From: [REDACTED]
To: [REDACTED]
CC: [REDACTED]
Sent:
Subject: RE: O8W-PM 35217268, 35224712, 35224713 - Bucks Creek 1101 Phase 1,2&3 - Pre-Engineering Meeting
Attachments: Basemap Limits for PM's 35224712 & 35224713.kmz

Bucks Creek 1101- PM# 35217268 Overview Map

Subject: O8W-PM 35217268, 35224712, 35224713 - Bucks Creek 1101 Phase 1,2&3 - Pre-Engineering Meeting

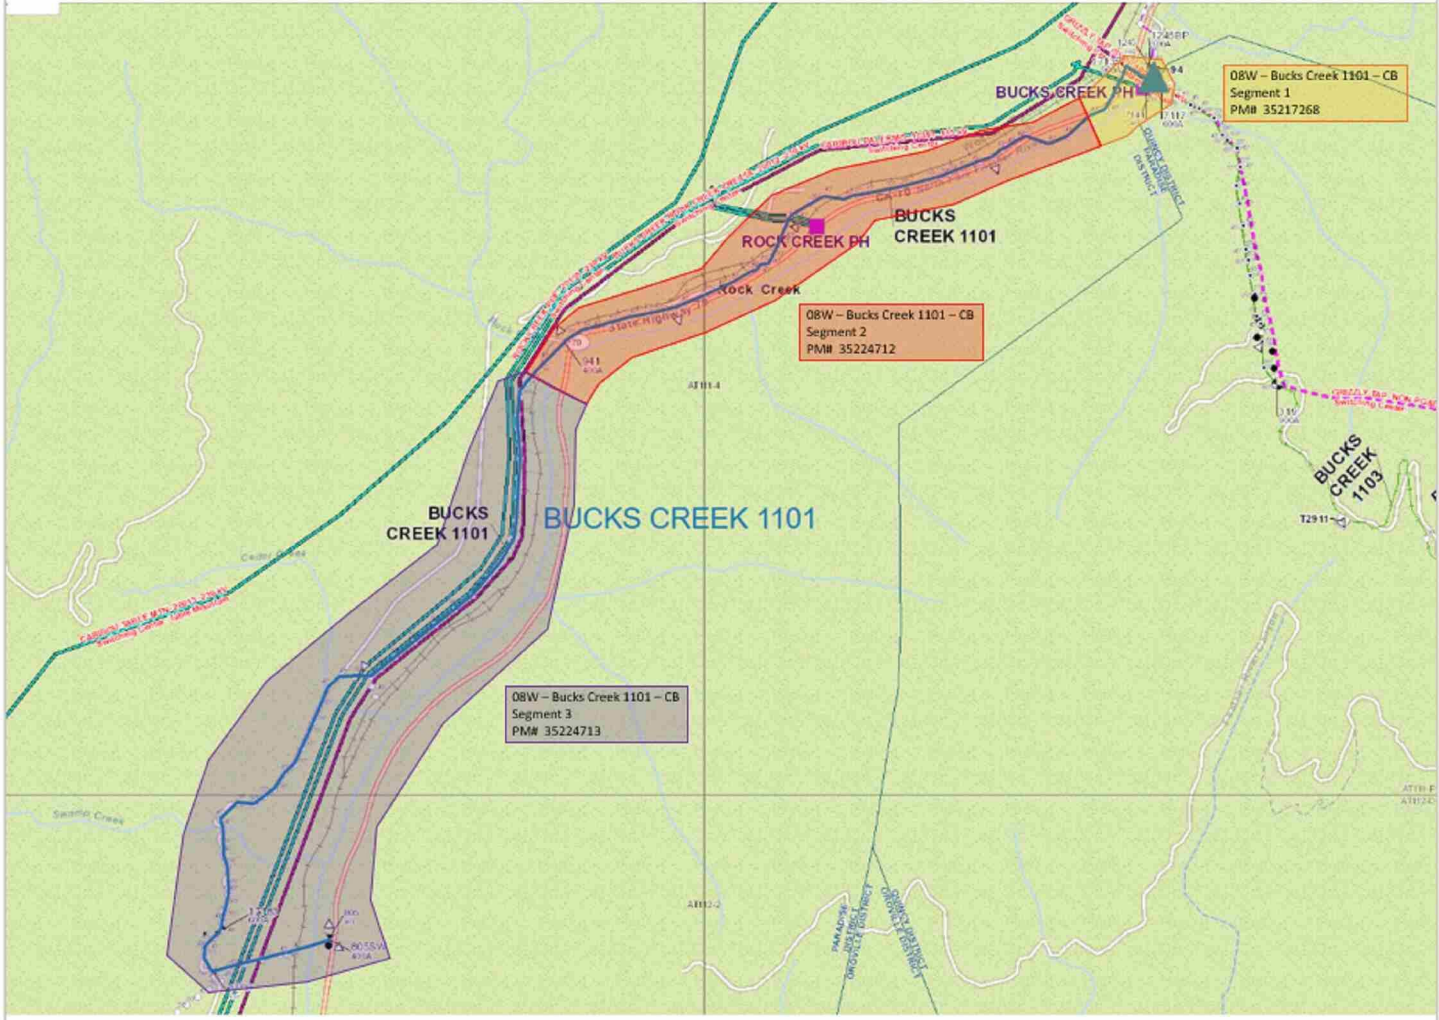
Attached are the 'base-map' limits in a kmz. file. As you will see, we need our base-map to go about ~100' into the tunnel at the south end (see pedestal in picture below... please begin about ~50 beyond this point which is about ~100' beyond the Cresta Dam.

We want to end the base-map at the sign location below which is roughly at MM (Mile Marker)
